JUNE 1, 2021
BROOKFIELD STREETSCAPE PHASE 3
STATE PROJECT NO. L018-0002
TOWN OF BROOKFIELD

ADDENDUM NO. 1

**BROOKFIELD STREETScape PHASE III
 OLD ROUTE 7 & LAUREL HILL ROAD**

CONCRETE DRIVEWAY DETAIL

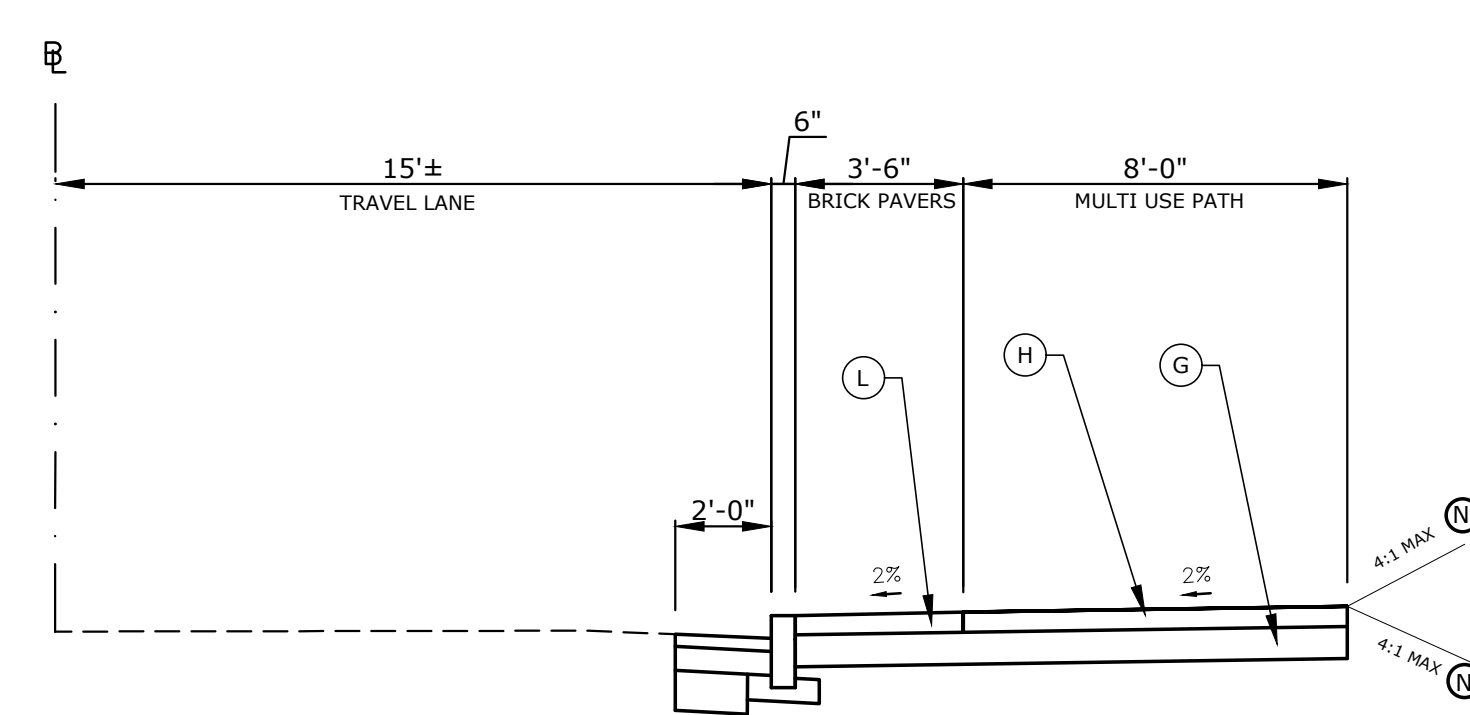
NO.	DATE	DESCRIPTION	REVISIONS
1	5/26/21	CONCRETE DRIVEWAY DETAIL

TITLE:
ROADWAY PLAN
DWG NO.:
PLN-1
SHEET NO.:

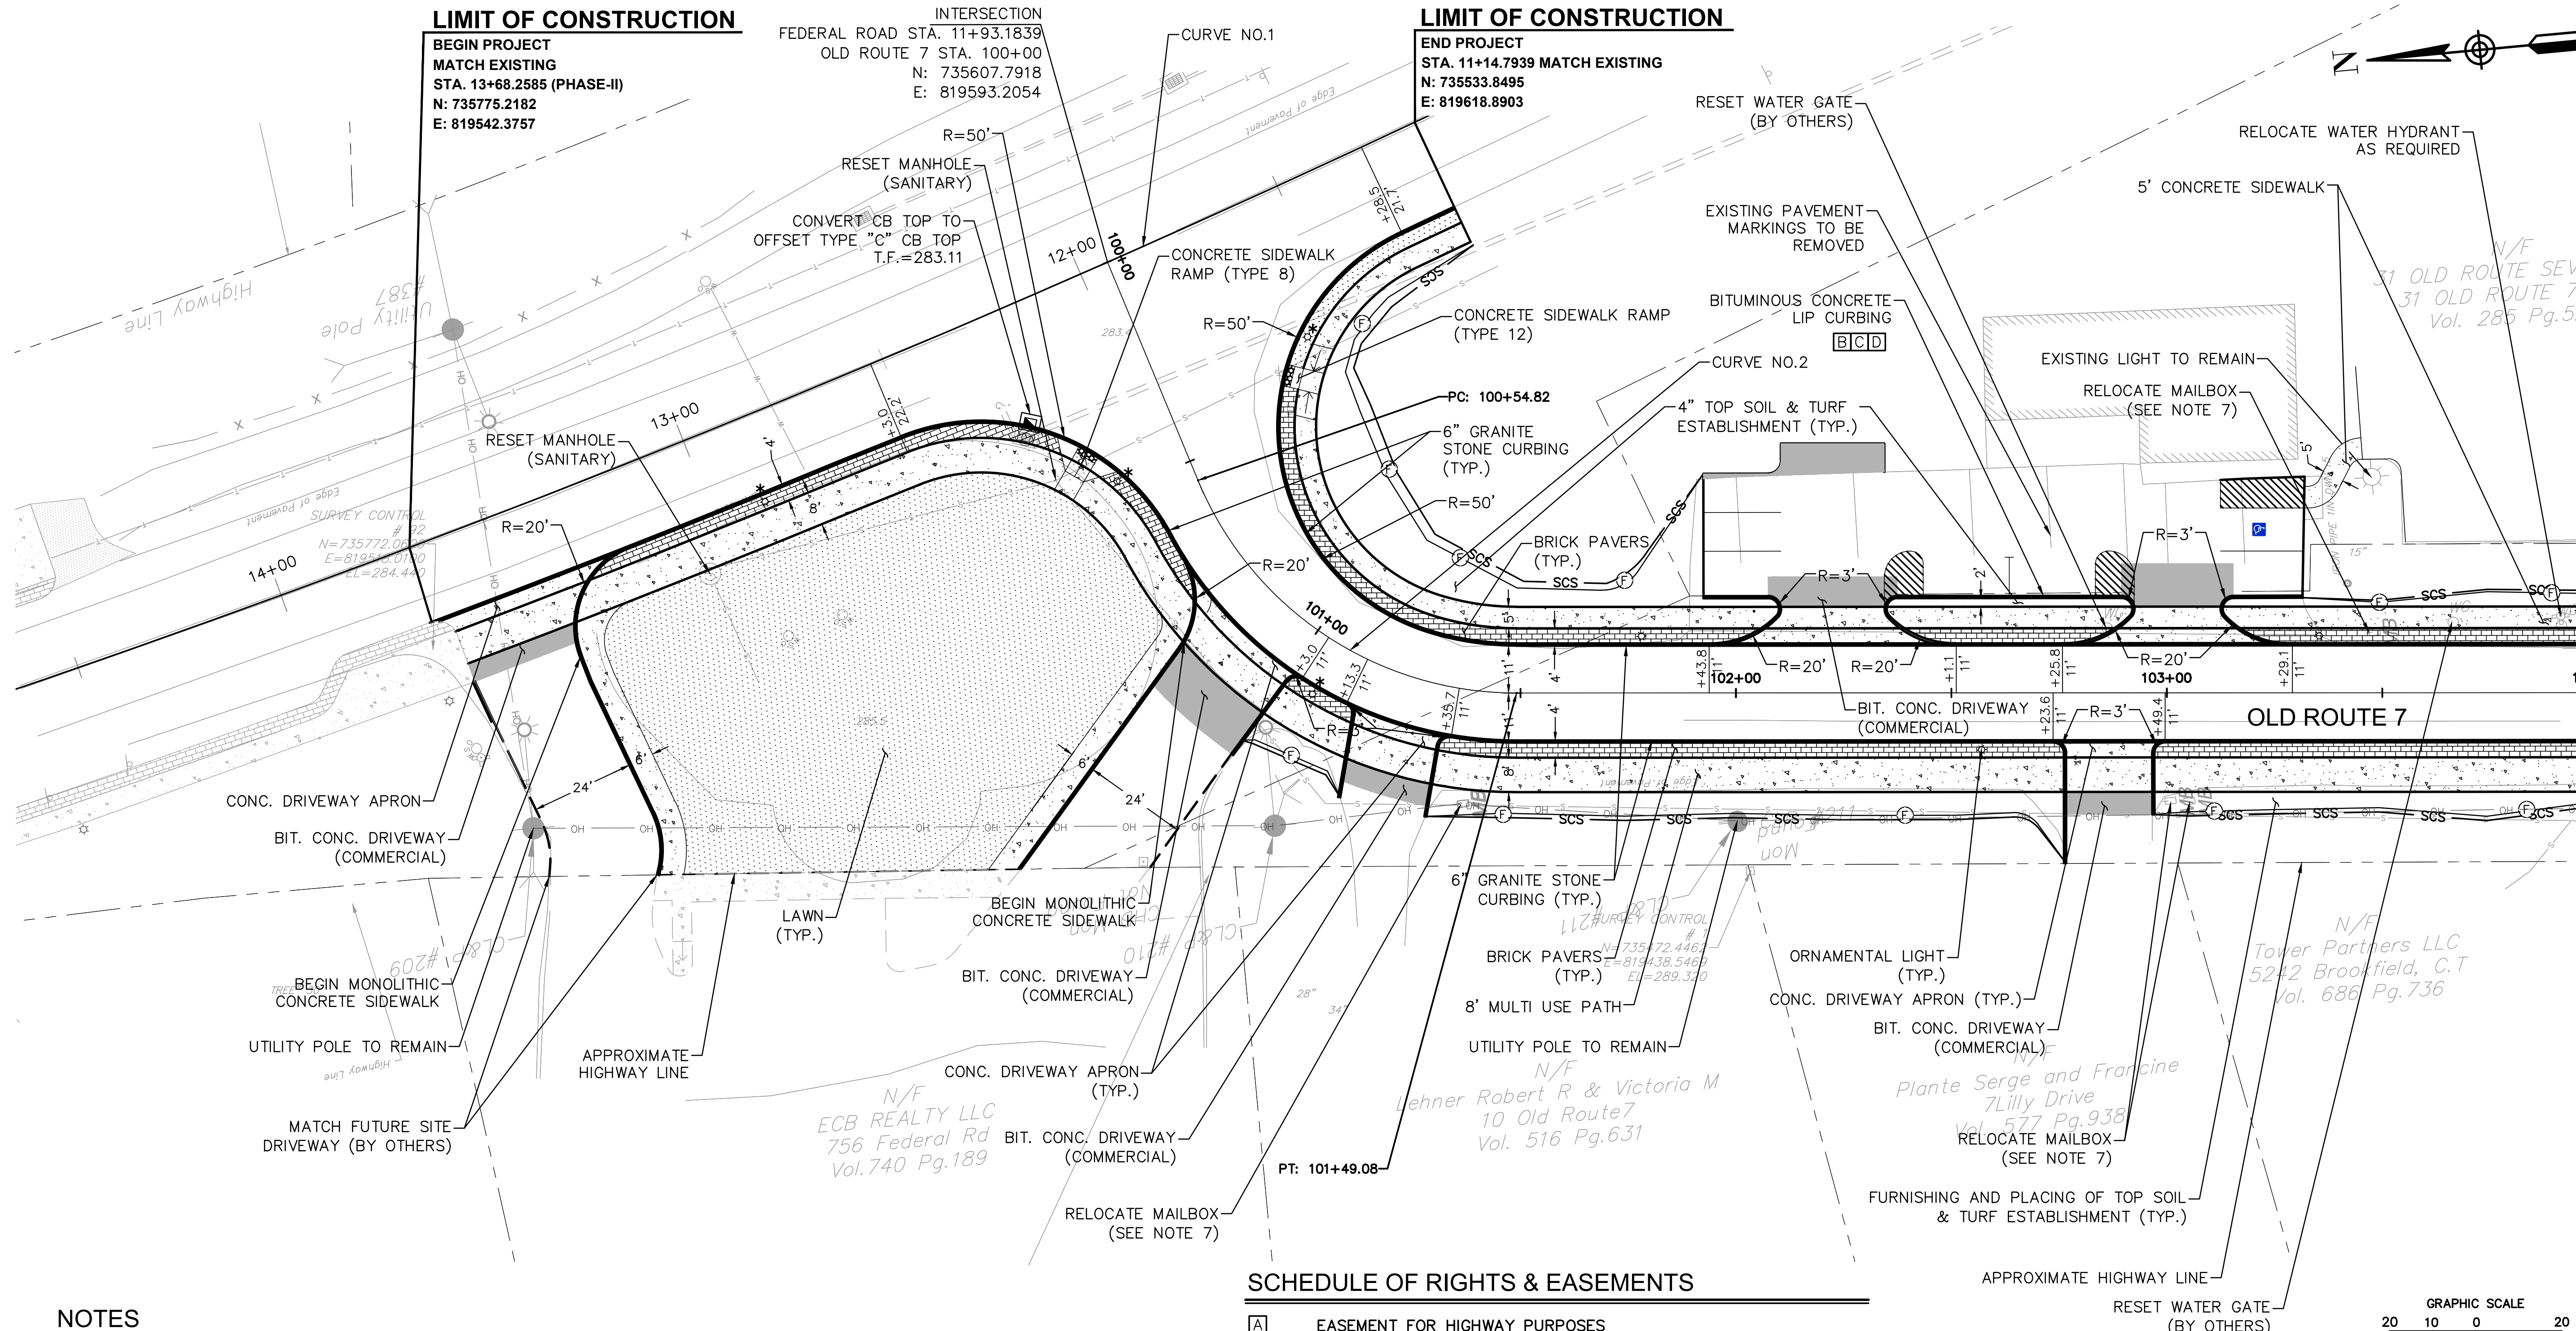
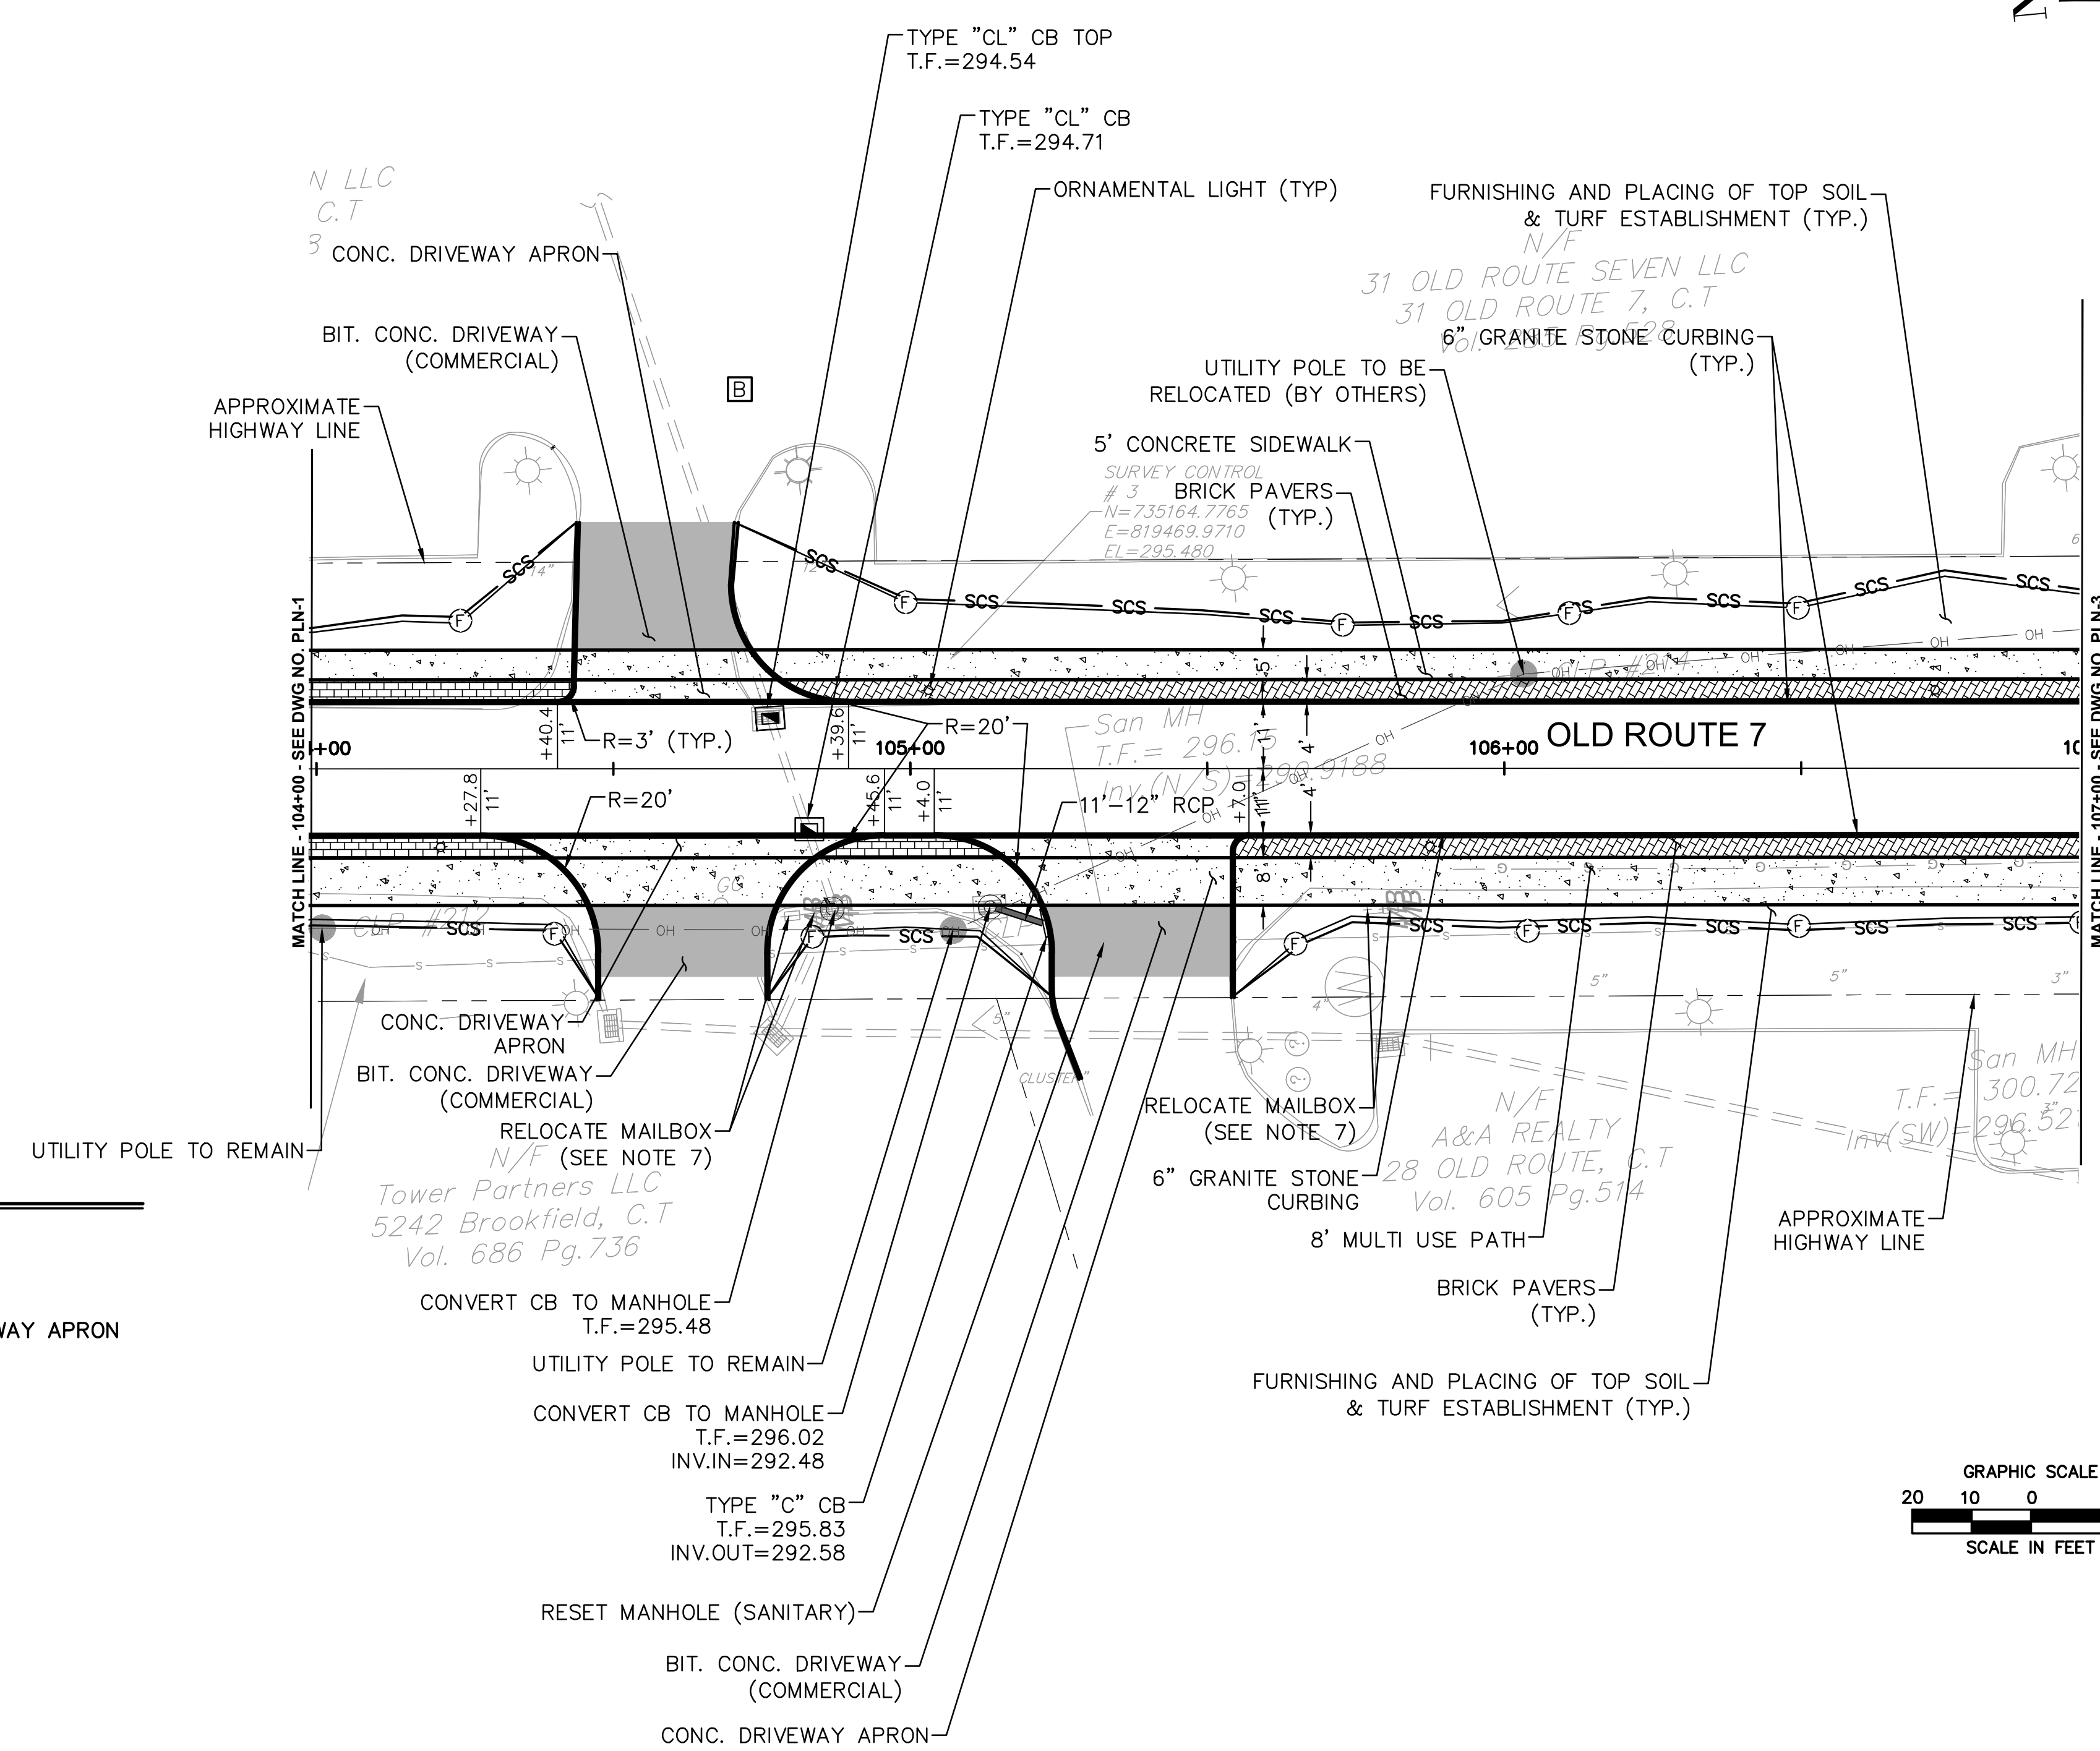
NO.	DATE	DESCRIPTION	REVISIONS
1	5/26/21	GRANITE STONE CURB TABLE

GRANITE STONE CURB

STA. 11+93 - 13+75 & STA. 100+00 - 104+00	
STRAIGHT	L=657'
R=50'	L=214'
R=20'	L=129'
R=90'-100'	L=98'
DRIVEWAY RETURN (R=3')	6 (EA)

DWG NO.:
PLN-3

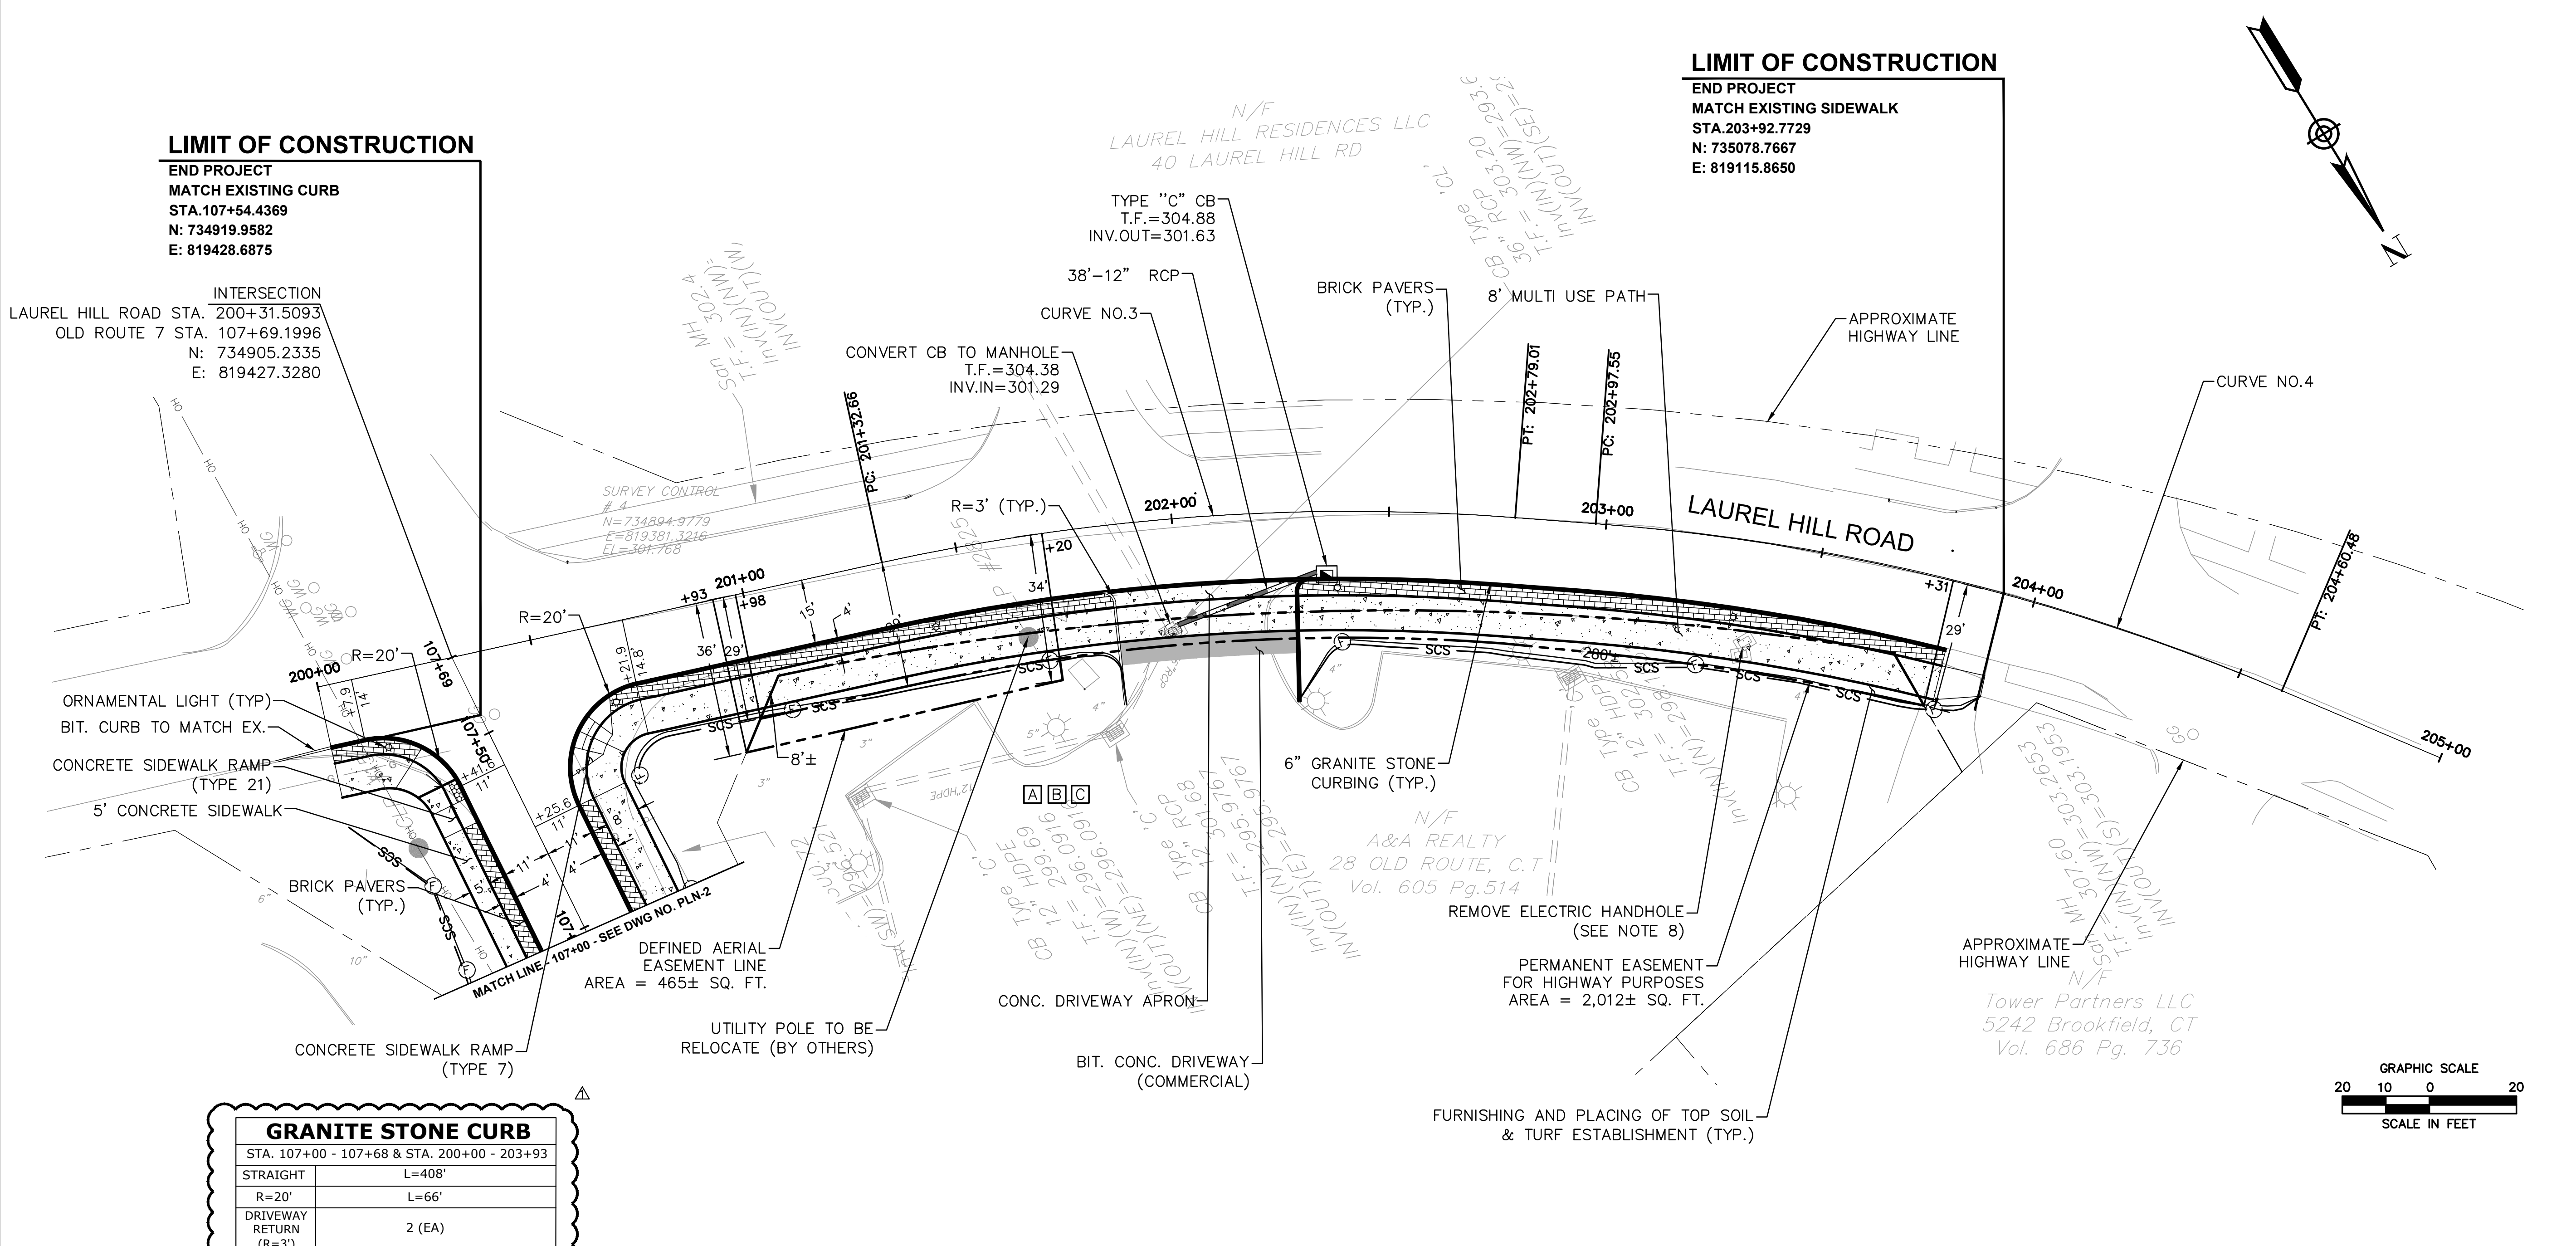
NO.	DATE	DESCRIPTION	REVISIONS
1	5/26/21	GRANITE STONE CURB TABLE

GRANITE STONE CURB	
STA. 107+00 - 107+68 & STA. 200+00 - 203+93	
STRAIGHT	L=408'
R=20'	L=66'
DRIVEWAY RETURN (R=3')	2 (EA)
